SEWAGE DISPOSAL TESTING

MARYLAND STATE DEPARTMENT OF HEALTH

PROPERTY OWNER Earl H. Heckman

RE: Earl H. Heckman & wife
property

PLAT OF SURVEY
 FOR
 EARL H. HECKMAN
 FIRST ELECTION DISTRICT OF HOWARD COUNTY
 ELLICOTT CITY, MARYLAND
 SCALE: 1 IN. = 100 FT. MARCH 17, 1971

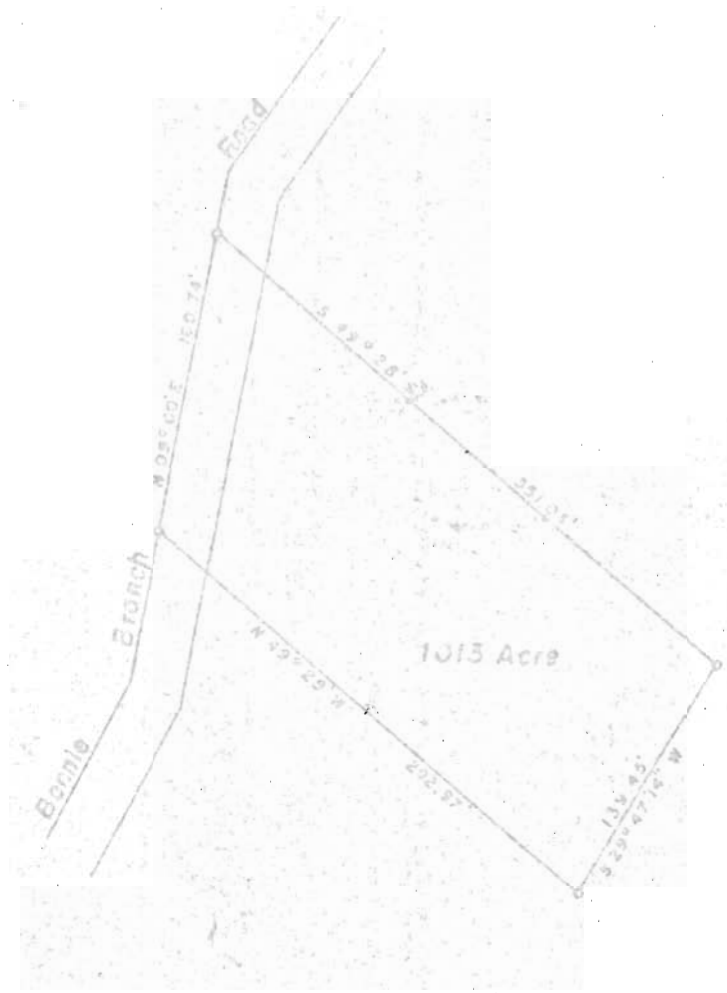
In view of the severity of the slope and the frequency of rocks and rock outcroppings this department doubts whether a properly functioning septic system can be installed on this property. Should the property be adjudged acceptable subsequent tests will be necessary to provide adequate repair area in order for the lot to be approved. Several of the tests for this property have been over the limit.

The plat accompanying your letter seems to be in error in that it shows three (3) test holes when our records show only two (2) test hole for the lot presented. This leads us to question the slope grades thereon indicated. Further the manner in which the grades are presented are such as we have never seen before and give no indication of how far they carry or the total lot picture. The State Law states; that, grade slopes of 25% or more are not included in the minimum ownership requirements. Therefore, we ask that the grades of the lot be presented in the usual manner of contour lines so that it can be seen that portion of land if any is excluded. The minimum ownership statement will be needed on the final plat.

Upon conducting the additional tests and receiving the aforementioned information the department will be able to ascertain the suitability of the property for the purpose of a septic system to serve a residence.
